## DOCUMENT CHANGE REQUEST

DCR number 371

Title: CMOS 8-Stage Shift and Store Bus Register with Synchronous Serial Outputs and 3-State Parallel

Number: 9306/026

TIMING DIAGRAM

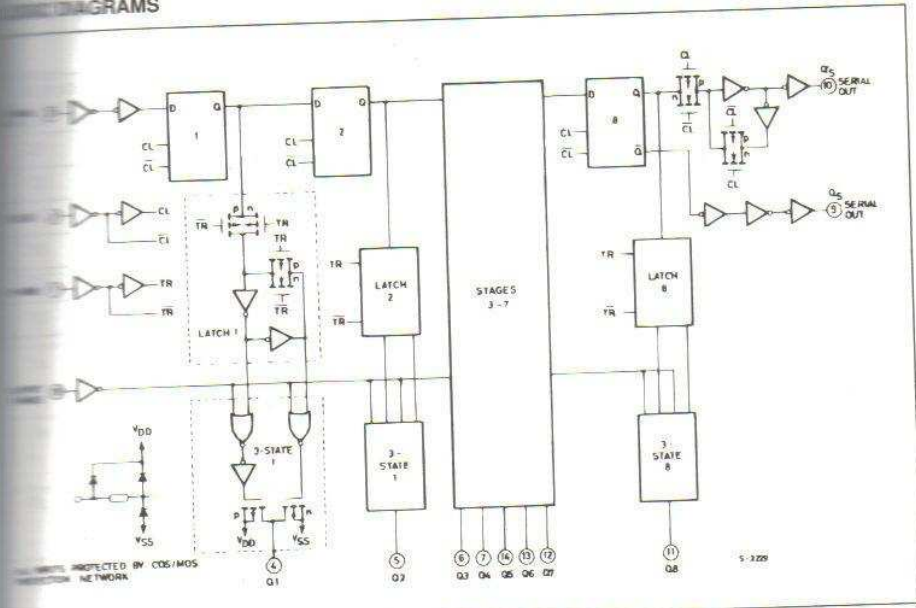
timing diagram is wrong.

during migration from old ESA/SCC form to ESCC form, the diagram was copied and an error was introduced: the second negative pulse of STR shall start at the next falling front of CLK (in the same time as OE).

Good diagram is proposed in attached file
